MOORE PUBLIC SCHOOLS
BOARD OF EDUCATION
MOORE, OKLAHOMA

CHILD CARE FACILITY
201 N. EASTERN AVE.

Construction Bulletin # 05

Client: Abla Griffin Partnership
Project Name: MPS Daycare
Project Number: 2450-70304-00

1 MECHANICAL FLOOR PLAN

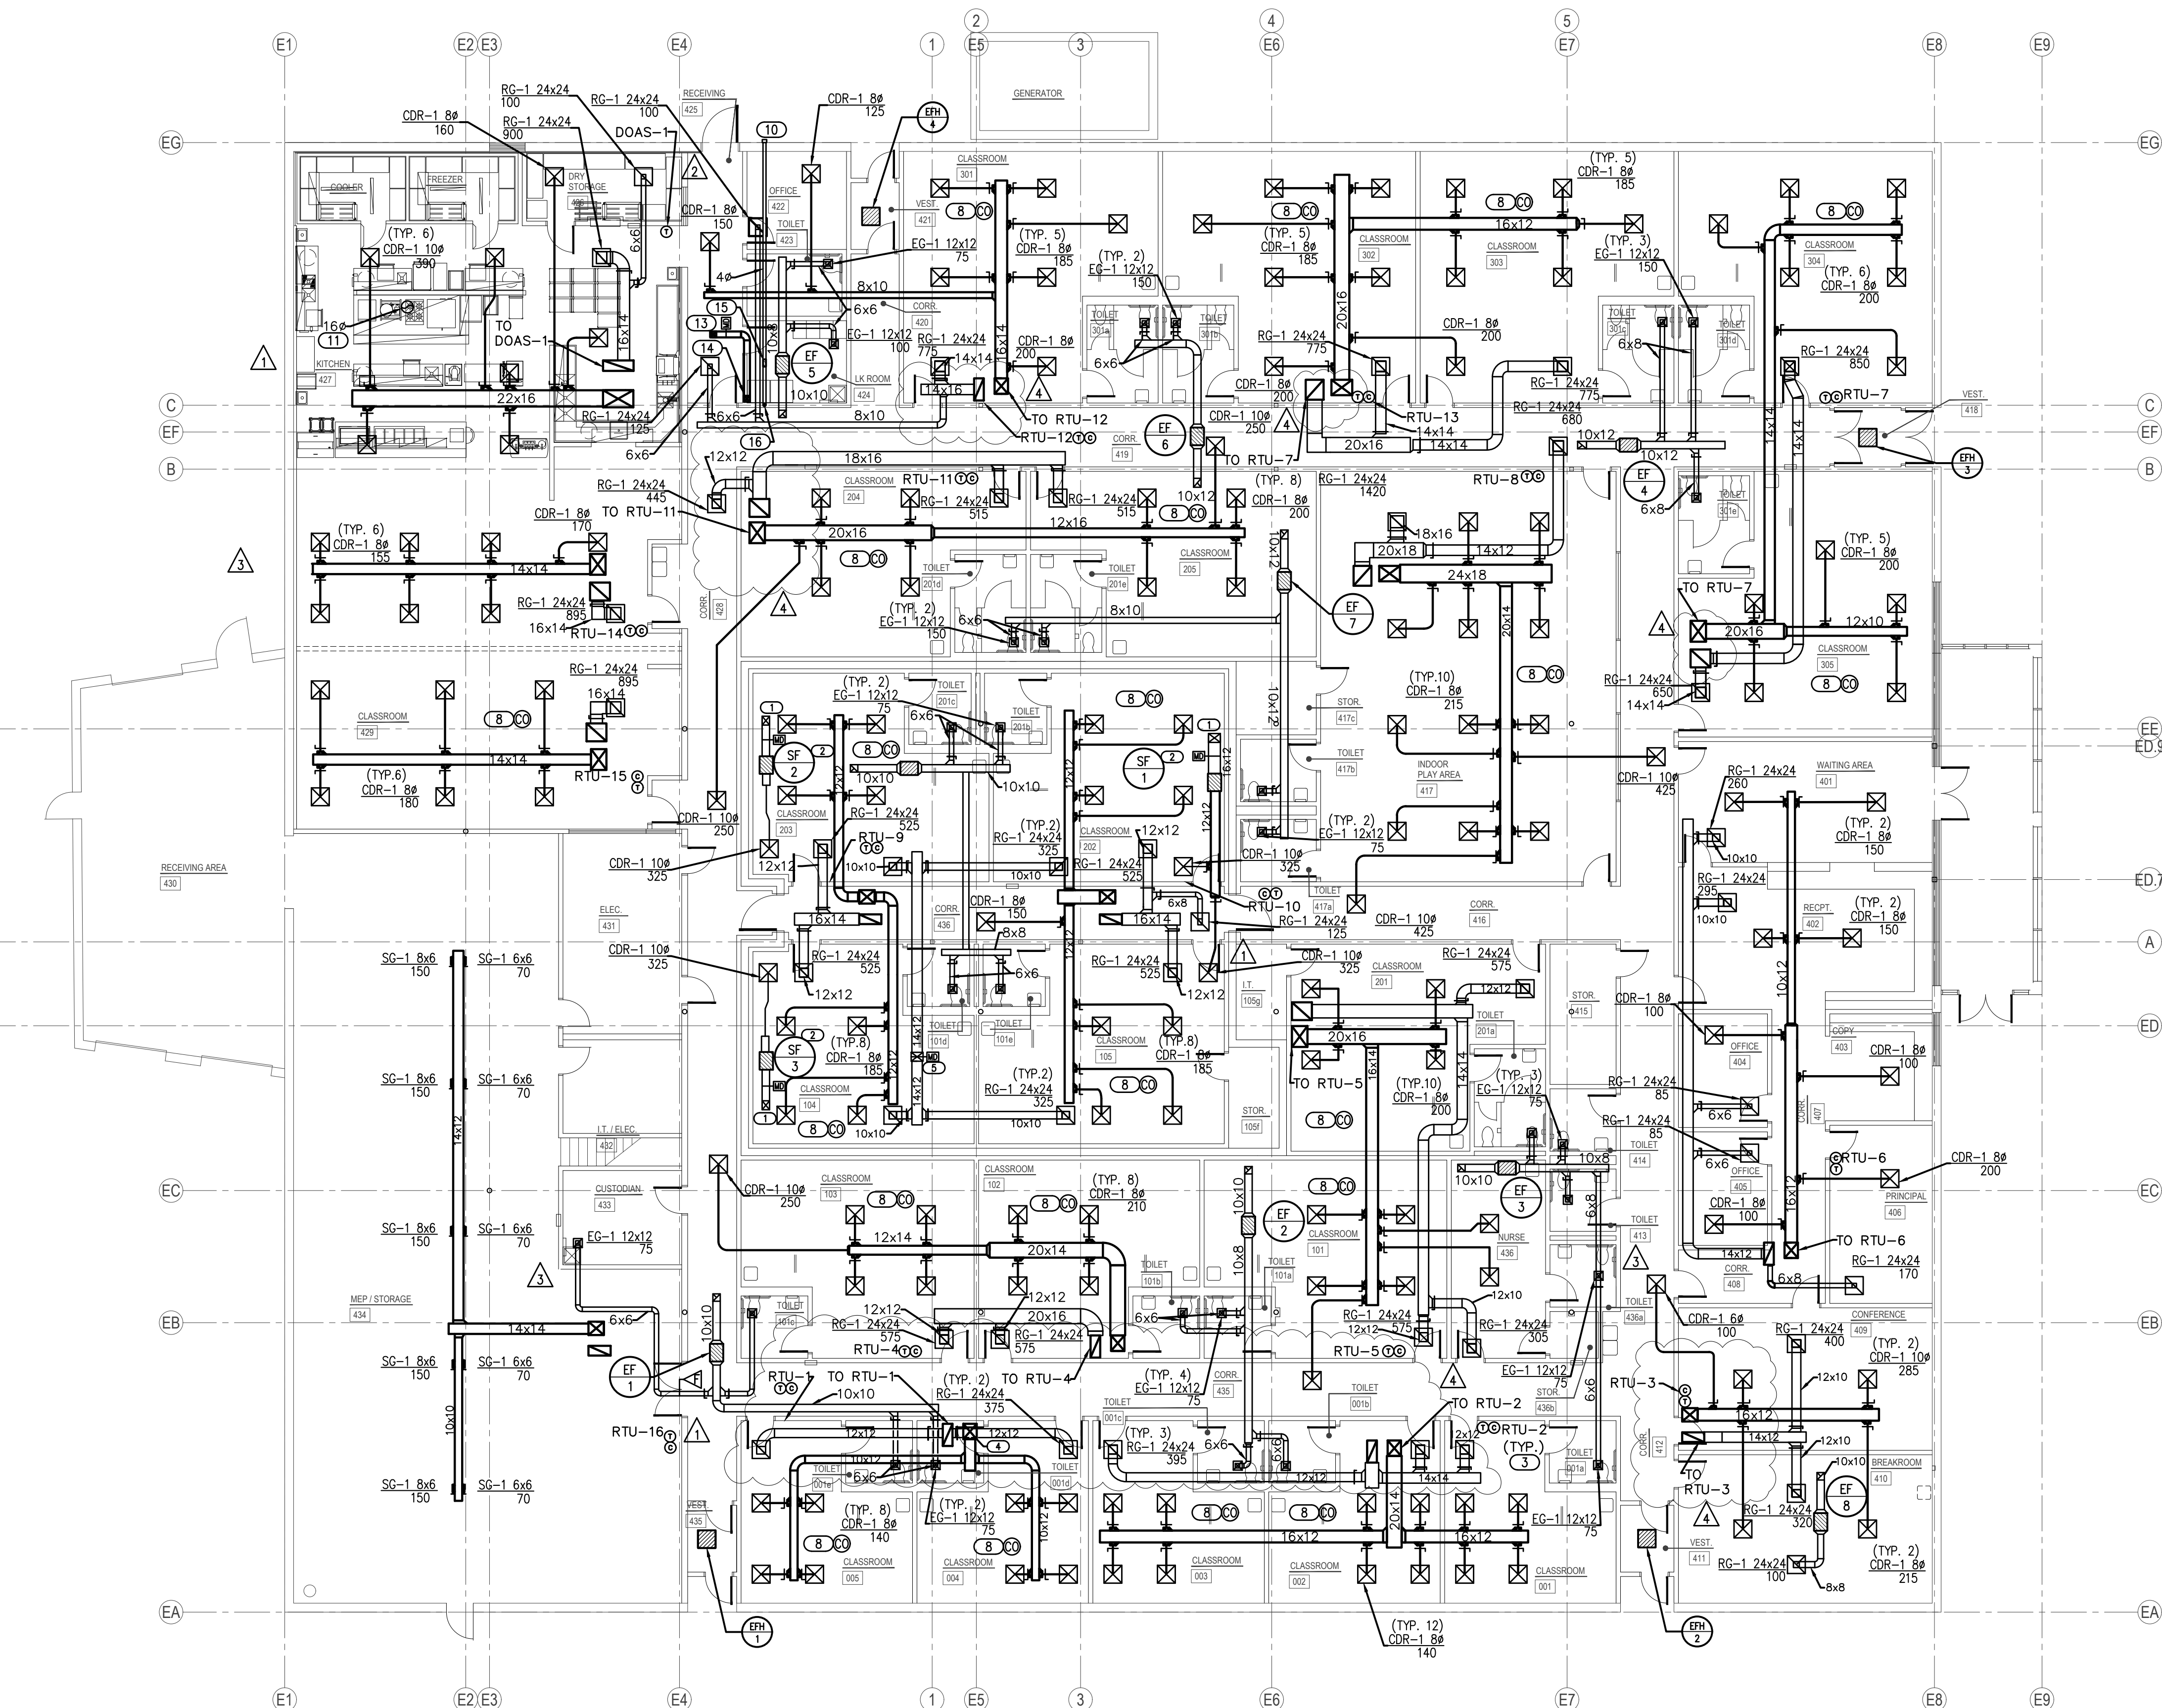
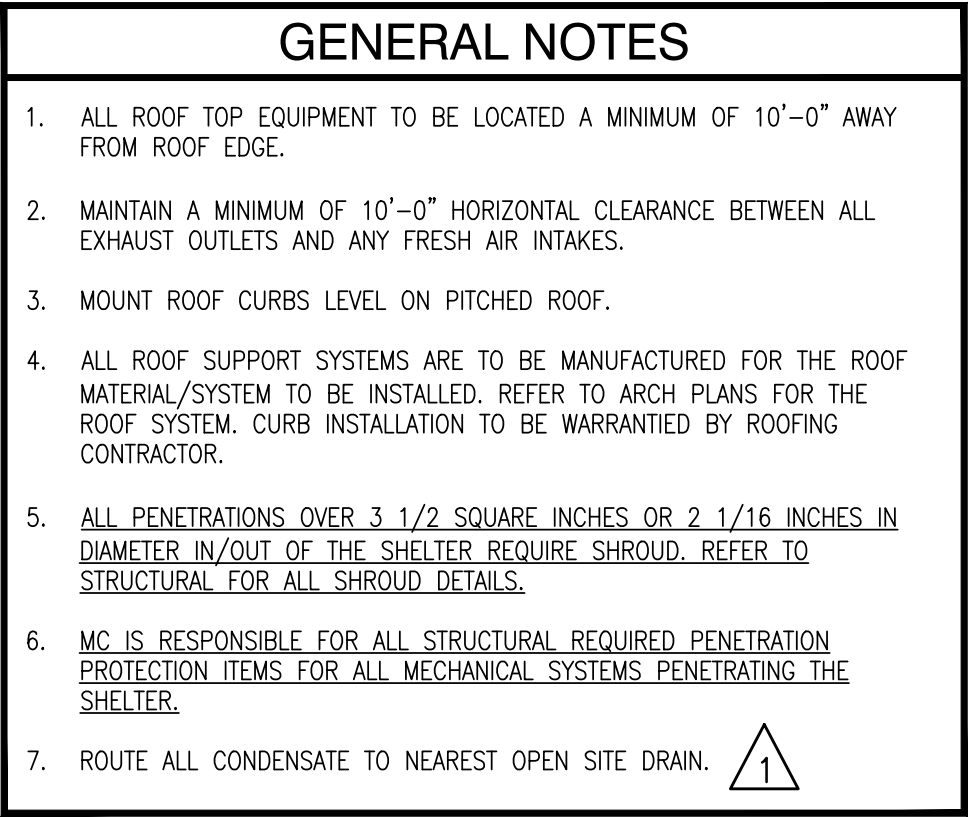
Item No.	Description	Attachment
1	Refer to clouds and deltas.	M101
2	Refer to clouds and deltas.	M201
